EA Project No.: 16-1100

DATE OF ISSUANCE: February 14, 2017

Notice: This addendum is issued to all prospective bidders as an amendment to the Drawings and Project Manual for the Canopy Row. Bidders shall acknowledge this addendum on the Bid Form. All information contained herein shall be fully incorporated into the Contract Documents as though originally included therein.

1
A102 LOWER LEVEL FLOOR PLAN- BUILDING B
SCALE: 1/8" = 1'-0"

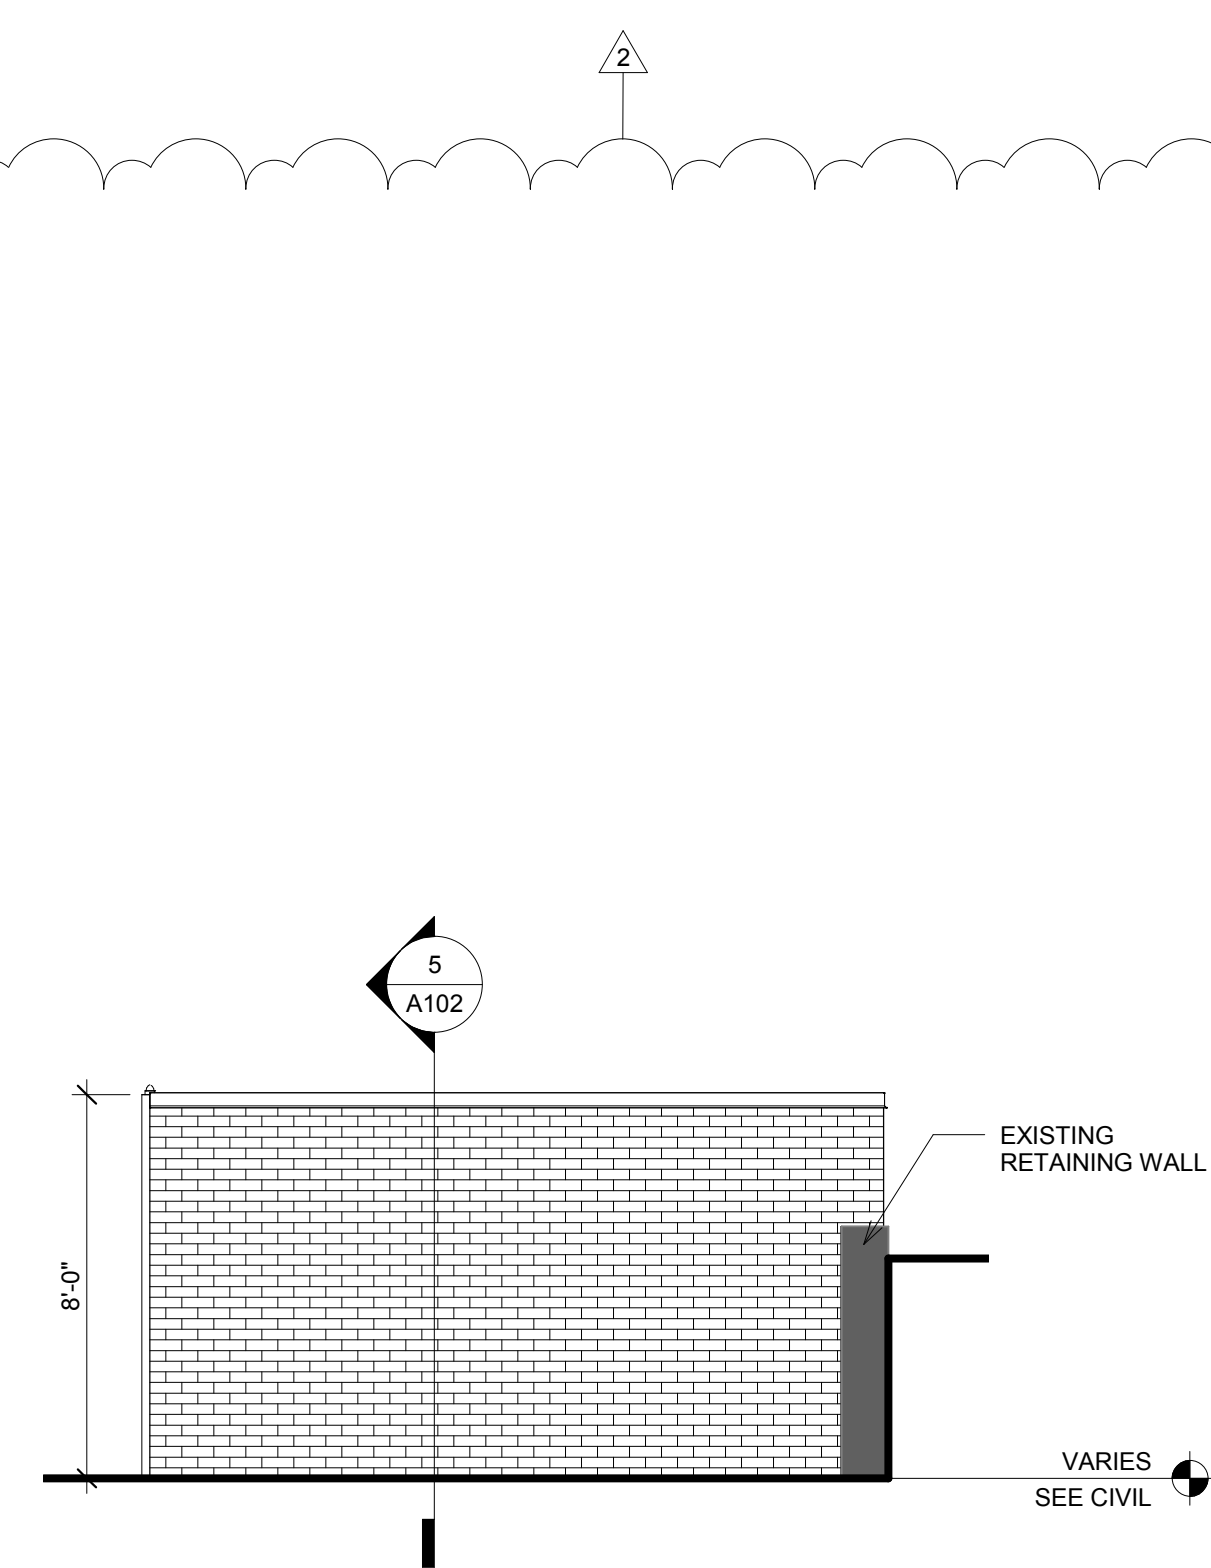
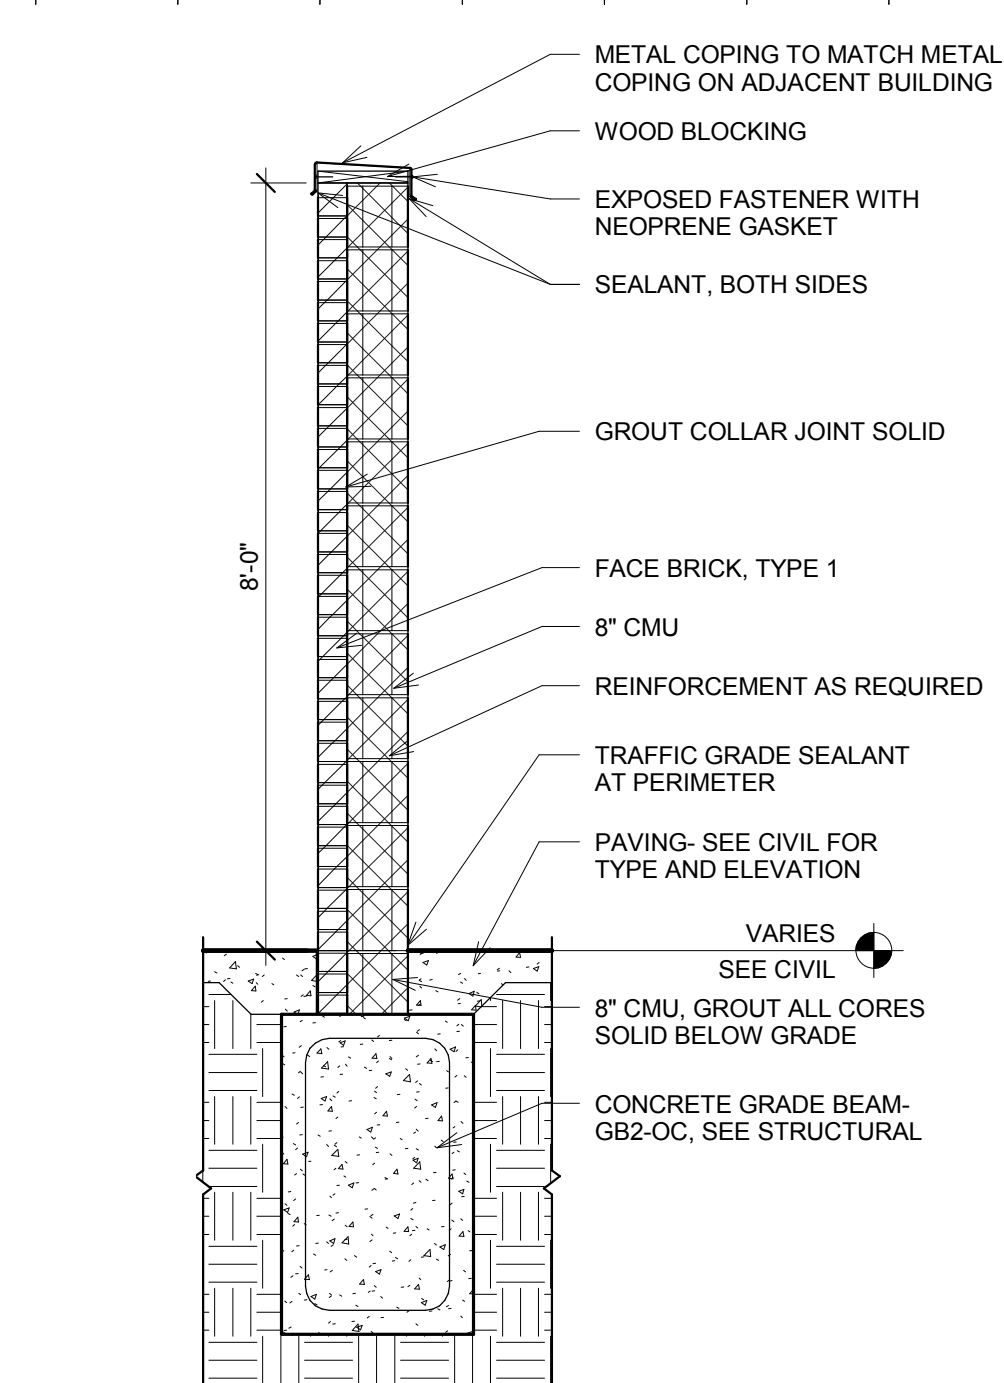
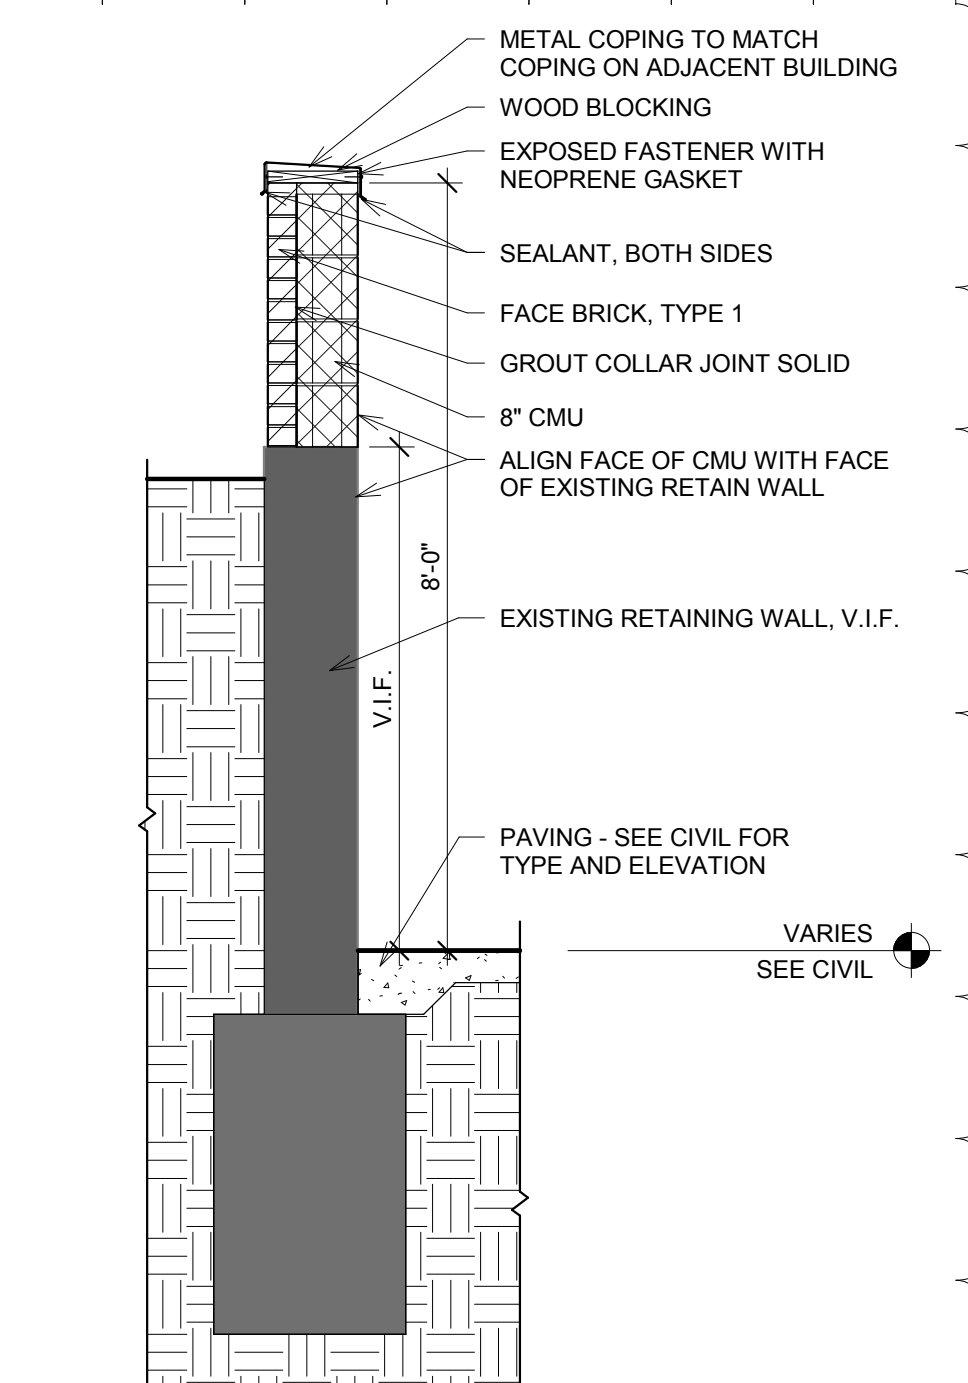
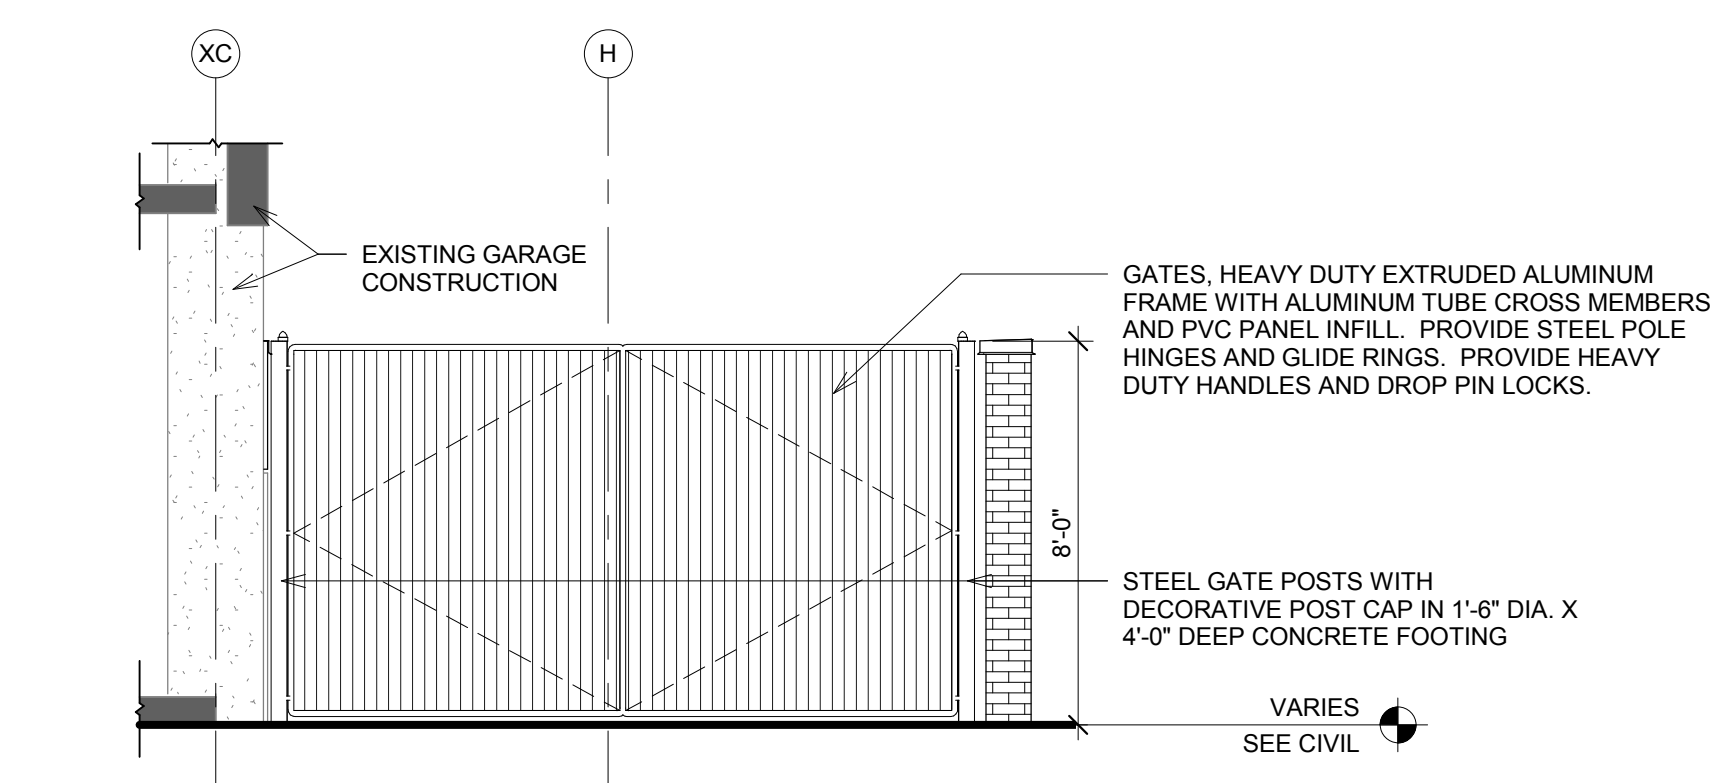
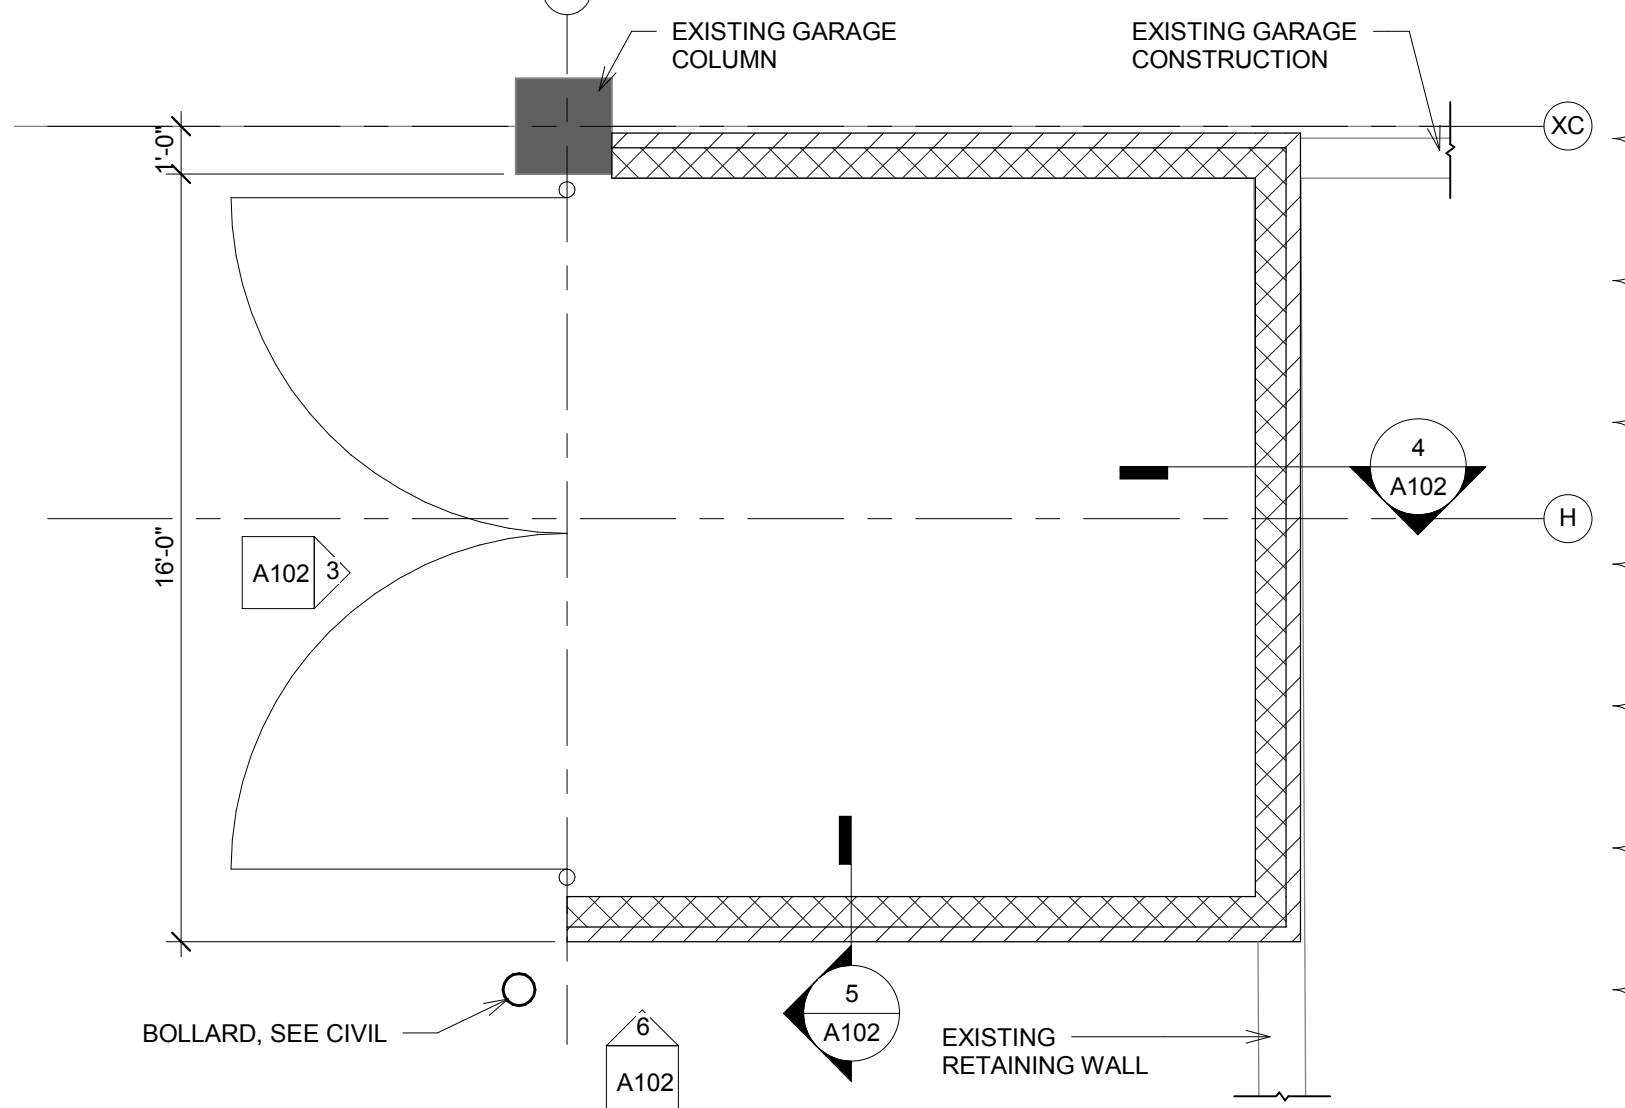
- Item AD-12. Sheet A102 – Lower Level Floor Plan – Building B
a. See attached sheet A102 for trash enclosure details.
- Item AD-13. Sheet A602 – Door and Windows
